Addendum #3: Cover Page

Project: Allen Bowden Public Schools – Activity Center

RE: Addendum #3

Addendum Number: **Three(3)**

U772

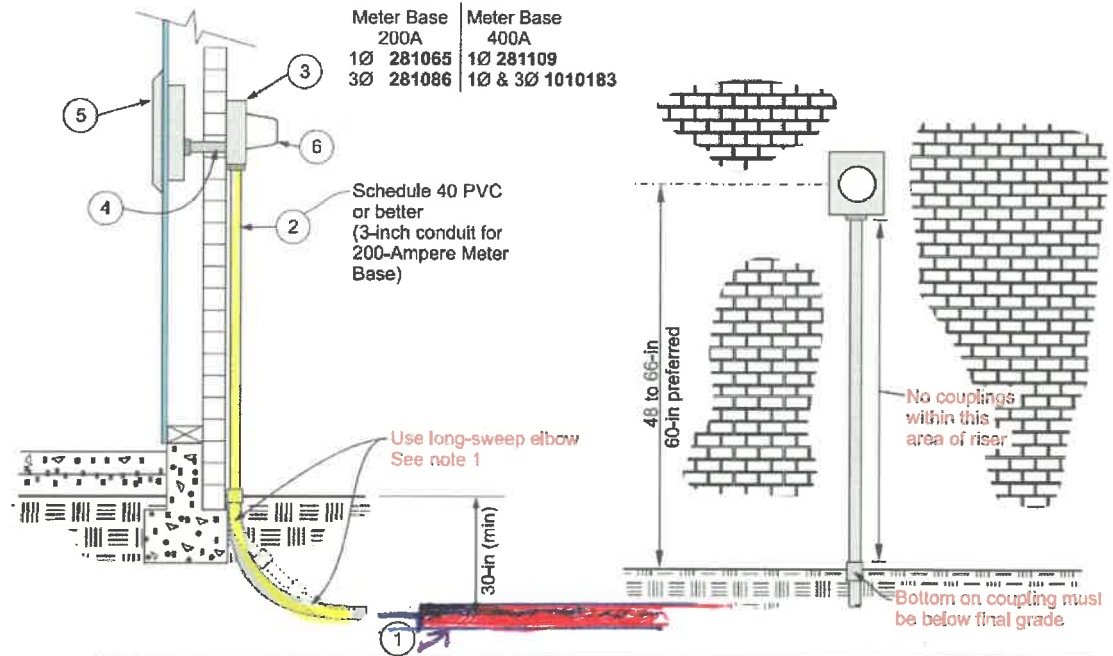
- Primary Side* - what's needed (if anything). Excavation, conduit (w/ size, count, if pull string or wire, depth, etc.) OGE will install the pvc and conductor from the transformer pole to the meter on the building. The electrician will need to install a 4" PVC downer 30" in the ground per U772

- Meter Base / Can - what's needed (if anything) When ready for install, I will order the 3phase meter base for you. Pick up is Locke Supply Sapulpa. Refer to U772 (attached) for more details. We will supply a 400A meter base for the 225A service.
